Expansion of Lelystad Airport

How to optimize airspace design to accommodate air traffic bound for Lelystad Airport, a study.

*Hadriaan van Nes
KNVvL Study Group Airspace
Version 1.5
Woerden, July 24, 2017*

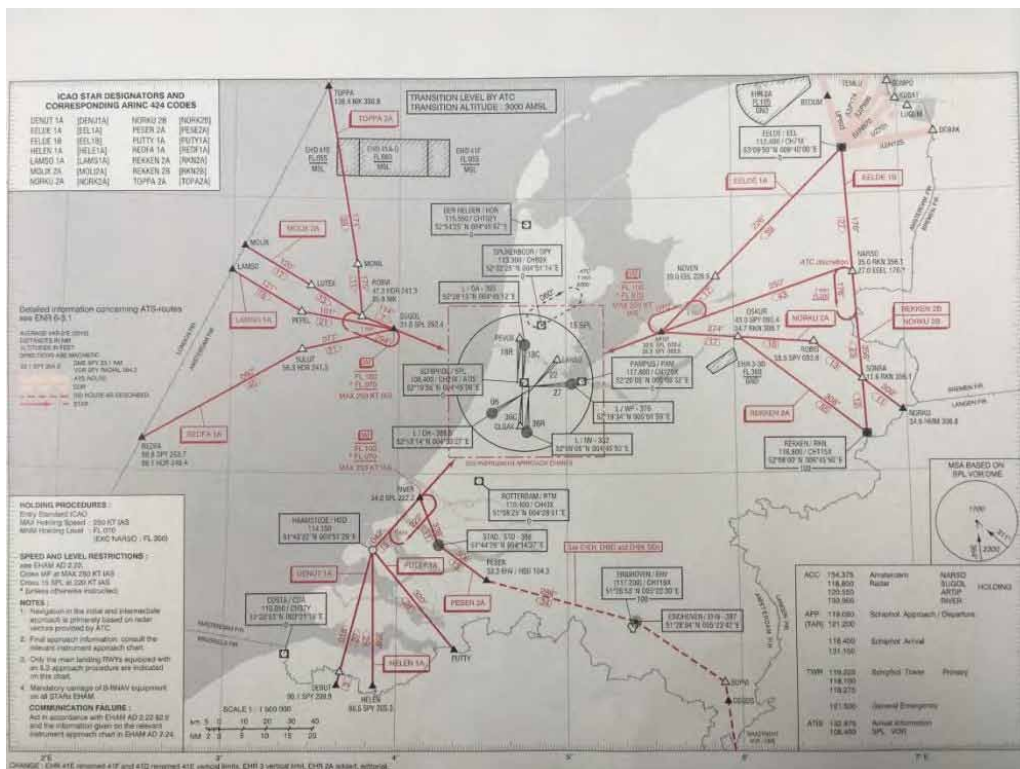
By not consulting the stakeholders in the general aviation beforehand, uncertainty is created by the ministry. The SGA is afraid that a great part of unused airspace remains unused. Airspace that is available to accommodate EHLE traffic. The gliding clubs ACS, ZCNOP and ZCFlevo will face stringent restrictions due to the planned route structure and holding patterns. On an “Alderstafel” sidetrack the gliding club ZCFlevo is in the process of moving their activities towards the main land. The ACS is only mentioned in government documents as a club who still needs to be informed about stringent restrictions, which restrictions is not mentioned. The gliding club ZCNOP is not mentioned at all in any government document.

The size of the EHLE CTR is of great concern as well. Almost the size of the complete polder of Flevoland. This reduces the flying activities of the GA in general and paramotor and paraglide activities West of Zeewolde.

8.

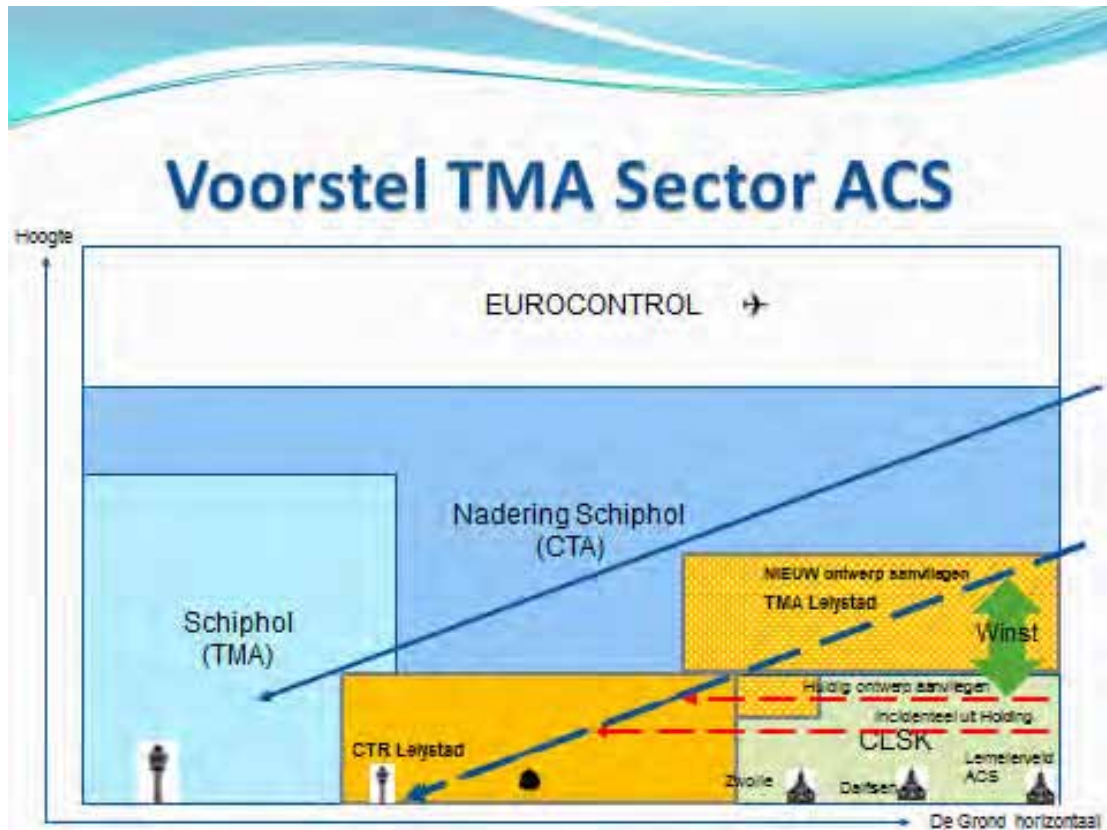
The present route and airspace proposal of the LVNL/CLSK for the CTR/TMA EHLE are unnecessary restrictive and thus undesirable. Especially while taking into account all threats the gliding clubs in this area are facing plus the GA in general.

- Increase the lower altitude of the ARTIP holding pattern by 1000 feet till FL80, this will have no effect on the Schiphol air traffic;
- Create a multi-stage TMA with a lower level of FL65 till the RNAV points OSKUR and NOVEN, West of these RNAV points the lower level will go down till 2500 feet in a multi-stage way; (fig. 8)

- The upper level of TMA EHLE will be at FL115 till the RNAV points NOVEN and OSKUR, West of these points the upper level will descent to FL75 in a multi-stage way;

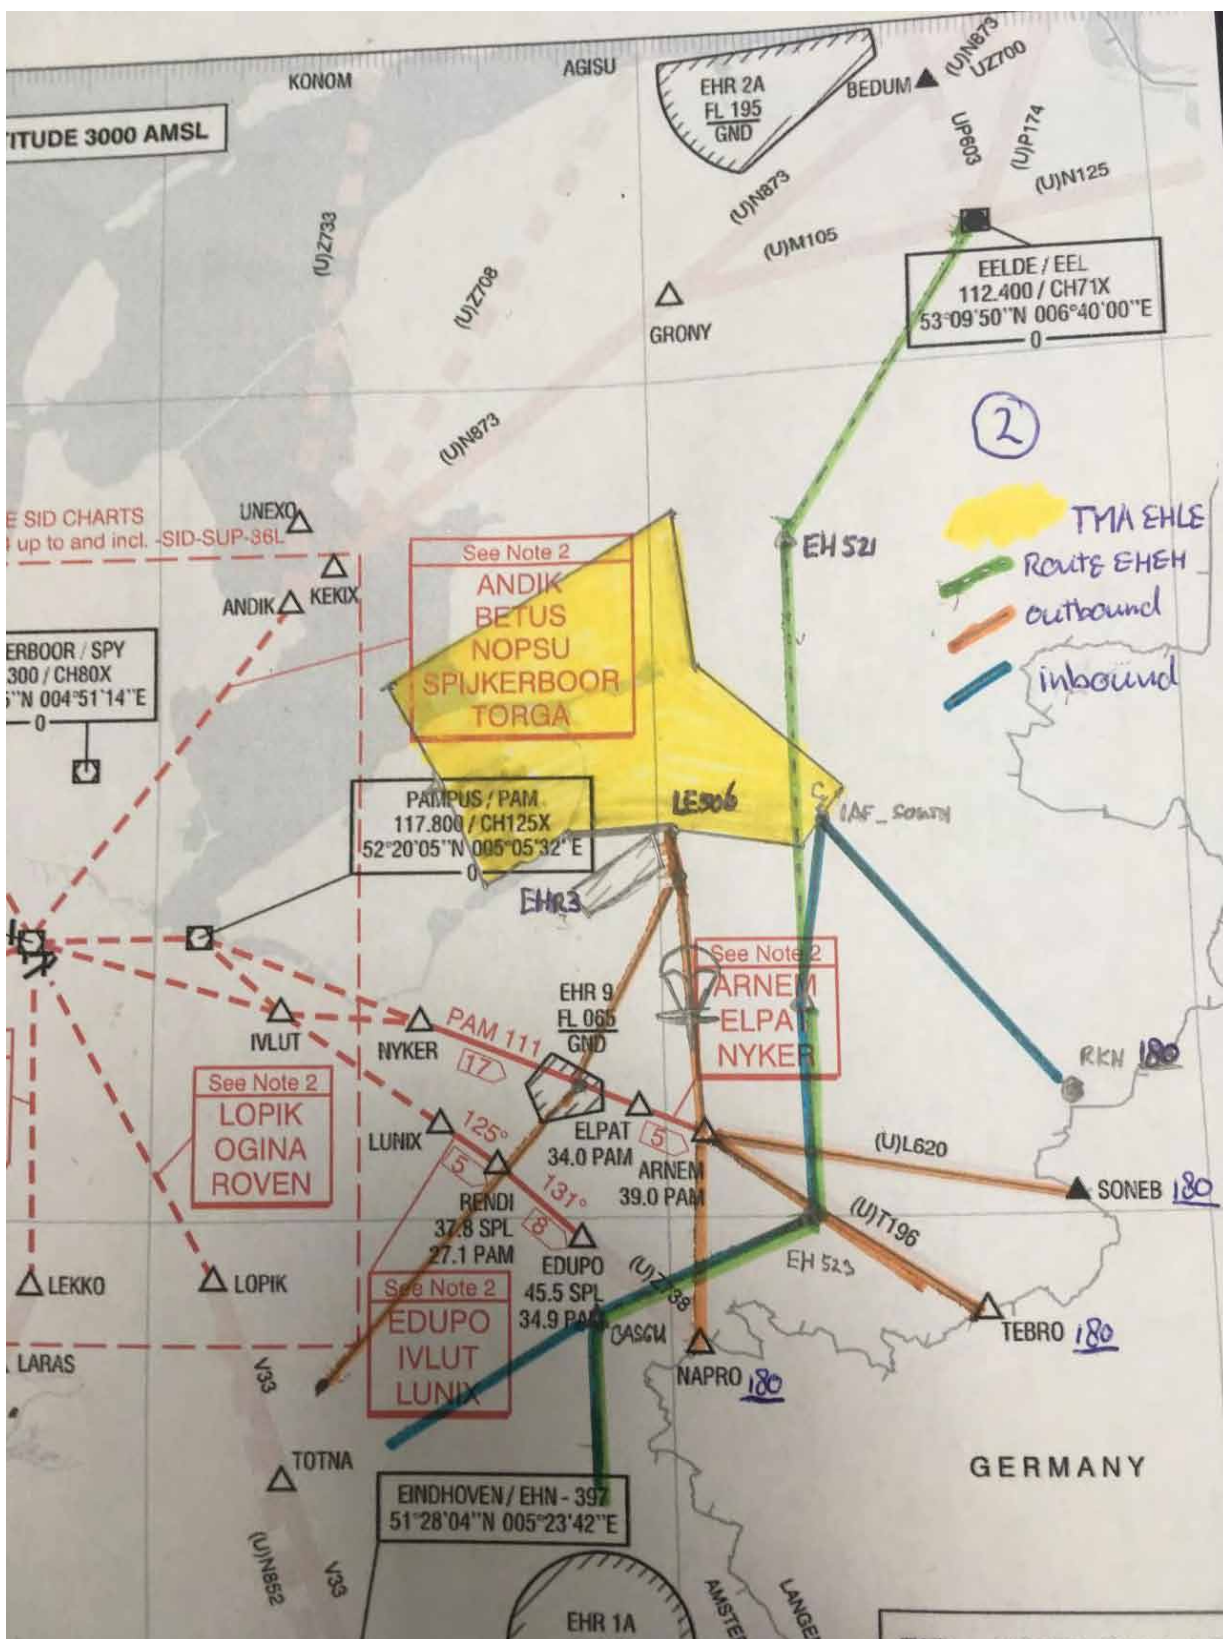
- The proposed routes result in unnecessary low flying for a long period by airliners underneath CTA Amsterdam;
- Air traffic bound for EHLE is the only air traffic which is not allowed to use CTA Amsterdam;

- Air traffic inbound Schiphol is no conflict with outbound EHLE traffic in the direction Southeast;
- Schiphol outbound traffic needs to cross the border with Germany at a sufficient high level so creating plenty of airspace in the area of Deventer-Apeldoorn-Arnhem. Without operational restrictions you can define airspace for arriving and departing EHLE traffic;

- Outbound route "OUT-02" is unnecessarily projected at a low level overhead the airfield of Teuge;
- The proposed maximum flying altitude overhead the RNAV point ARNEM on route "OUT-2" makes it almost impossible for airliners to cross the German border at the MCA of FL180;

- The length of the arrival route IN-02 towards IAF_SOUTH is too short for an approach with normal flying techniques; (Note: Regarding the MCA of FL180 at RKN the profile is perfect for a CDA, including deceleration segments, onto the final approach at EHLE, the approximate crossing altitude at IAF_SOUTH will be FL090

- There is a conflict in the arrival route IN-06 with the departure route OUT-2 and the routes via ARNEM-SONEB plus ARNEM-TEBRO, in altitude, route and airspace.

14. F

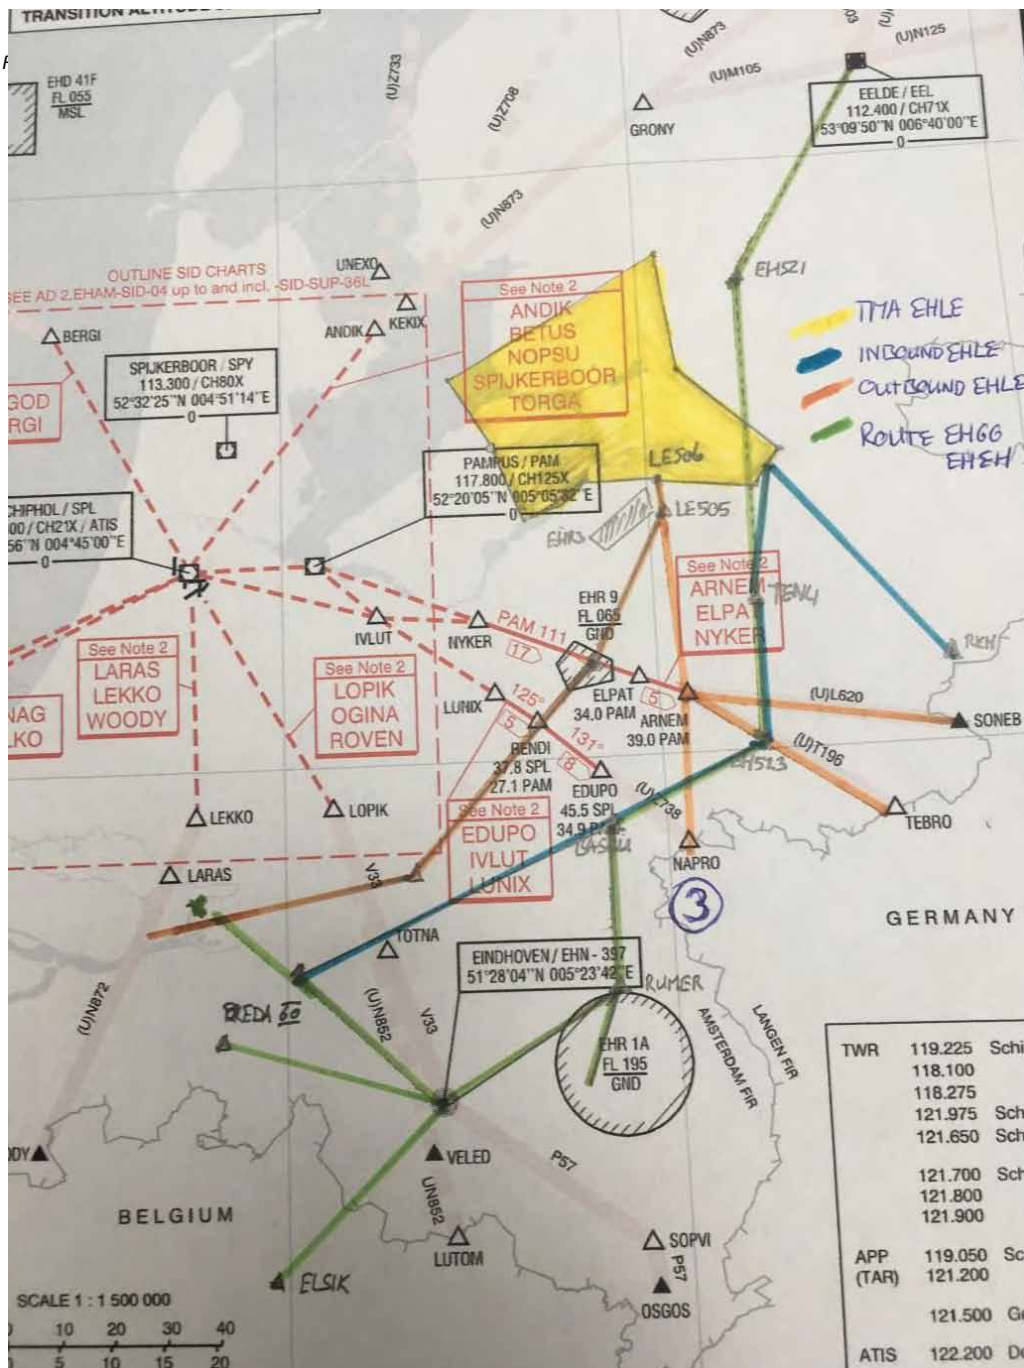
- Air traffic will have to fly along routes OUT-7, OUT-2 and IN-6 through Nieuw Millingen TMA D with a lower level of FL65 and higher level of FL195
- Within TMA Nieuw Millingen a TRA-12 and TRA-12A are situated, military exercise areas.
- All airways but one (UN852 via LOPIK to LNO) are one-way airways.
- There are not many options on connecting routes inbound the Netherlands arriving from the South.
- It is not clear at what level Brussels control accepts Dutch outbound air traffic.
- Route IN-06 is connected to a Southbound only airway UN872 via WOODY.

16. Routes north above the Netherlands, area 4

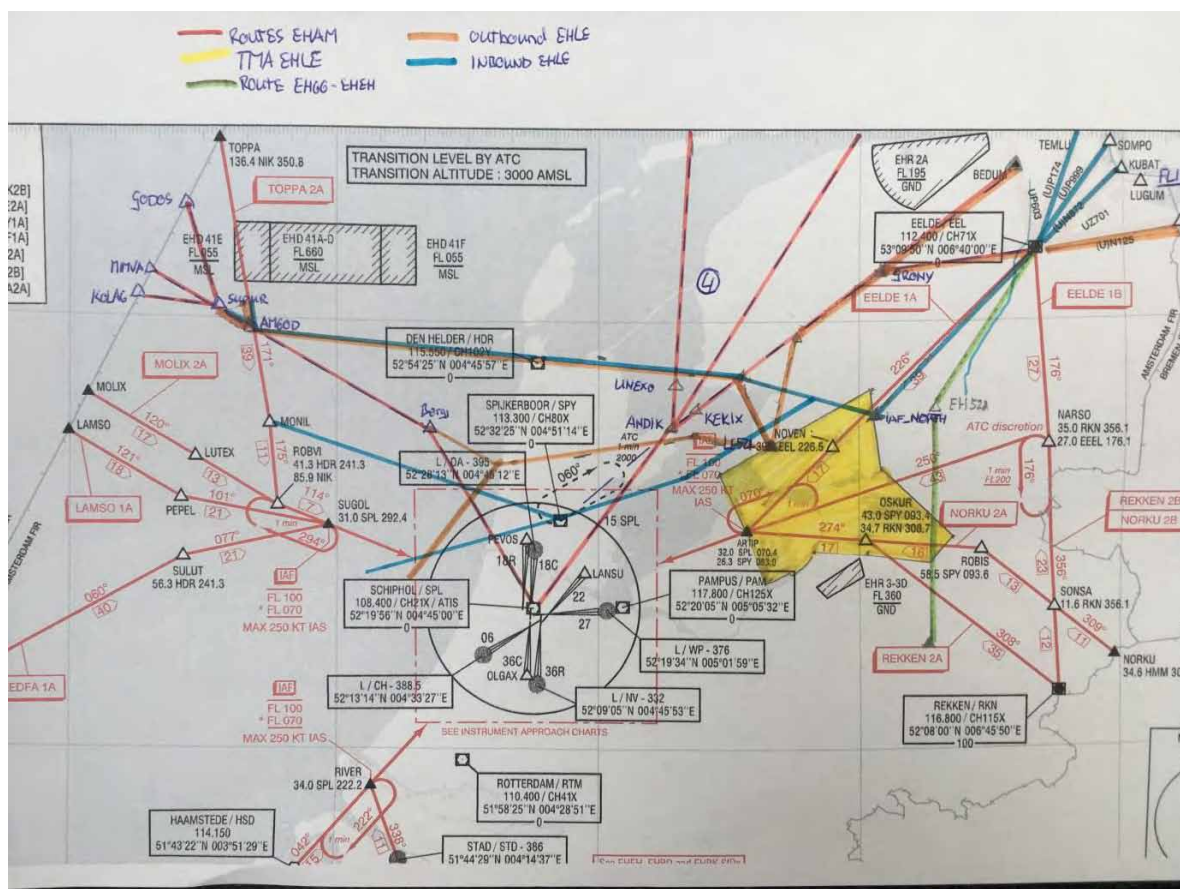
- The route proposal is crossing all kind of traffic above the Province of North-Holland.
- The routes IN-11 and OUT-12 are projected the same and at the same altitude, it is unclear if this is a maximum altitude;
- Routes IN-13 (A&B) are constructed at a realistic altitude along Schiphol through the Schiphol TMA;
- There is a very sharp turn projected in the route IN-11 and IN-13 at IAF_NORTH;
- Approaching and departing traffic to the North via the points EEL and GRONY are via existing routes without interference with other traffic (due to geographic distance between the two airfields);
- No altitudes are defined for route OUT-10 via ANDIK and DENAG;
- It's unclear when air traffic can resume their climb above FL60 on route OUT-1;
